UNITED STATES PATENT AND TRADEMARK OFFICE

APPLICATION NO.	FILING DATE	FIRST NAMED INVENTOR	ATTORNEY DOCKET NO.	CONFIRMATION NO.
10/797,839	03/10/2004	John R. Blake	47171-00390USPT	5664

Office Action Summary

DETAILED ACTION

FIG. 4

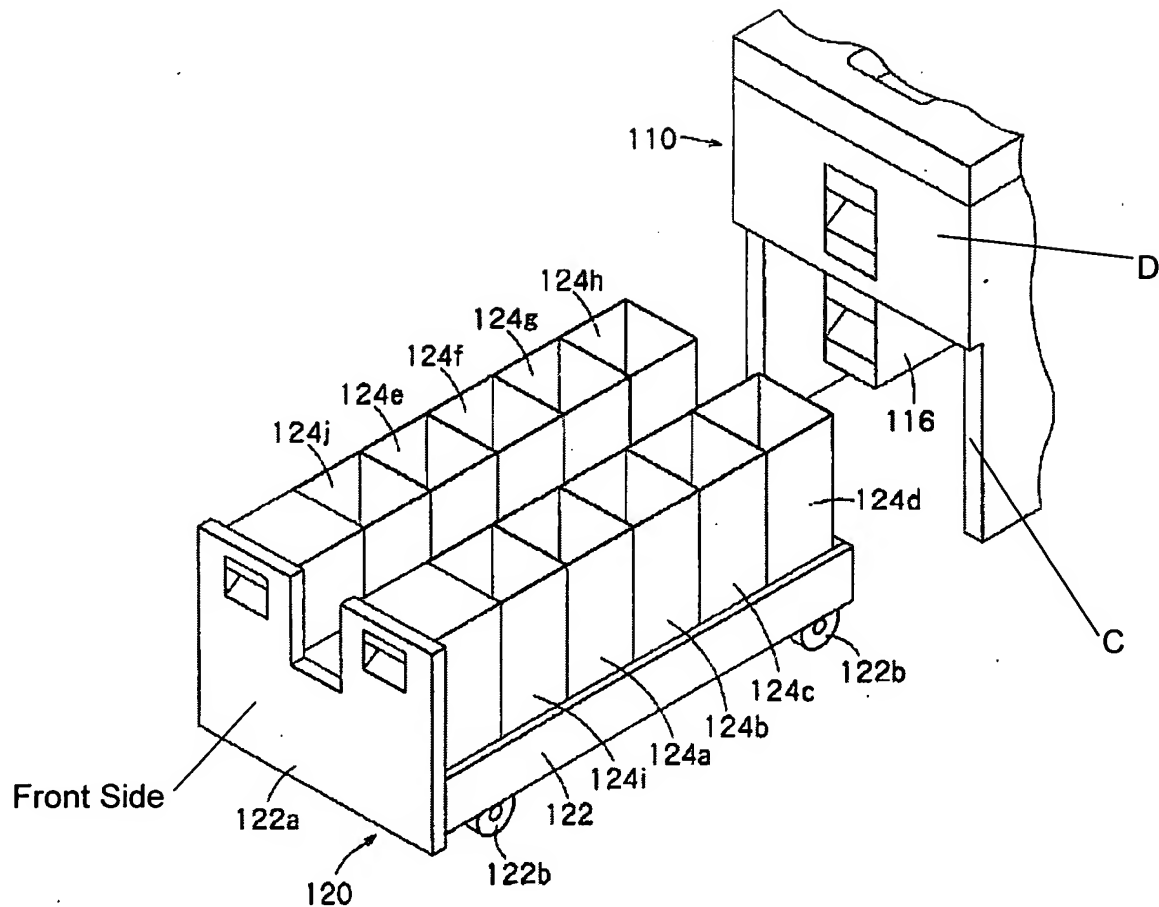
Claim 1: housing (See FIG. 2, 110); coin sorter (S); input hopper (112); rotatable disk (2); stationary head (1); lower surface ([0137]); shaped regions (10); exit channels (8a to 8c); coin receptacle station (120); coin receptacles (124a to 124j); first position (FIG. 2); second position (FIG. 4); manifold (location of 152); coin paths (152); dampening mechanism (See FIG. 4 below, C and 122a);

Claim 4: dampening mechanism (See FIG. 4 below, C and 122a); coin receptacle station (120); first end (See FIG. 4 below, C); housing (110); second end (See FIG. 4 below, Back Side (opposite Front Side) of 122a).

Claim 15: door (122a); rear side (See FIG. 4 below, D); housing (See FIG. 2, 110);

Claim 16: door (122a); front side (See FIG. 4 below, D; Note: the location of D can be defined as the rear or front side); housing (See FIG. 2, 110);
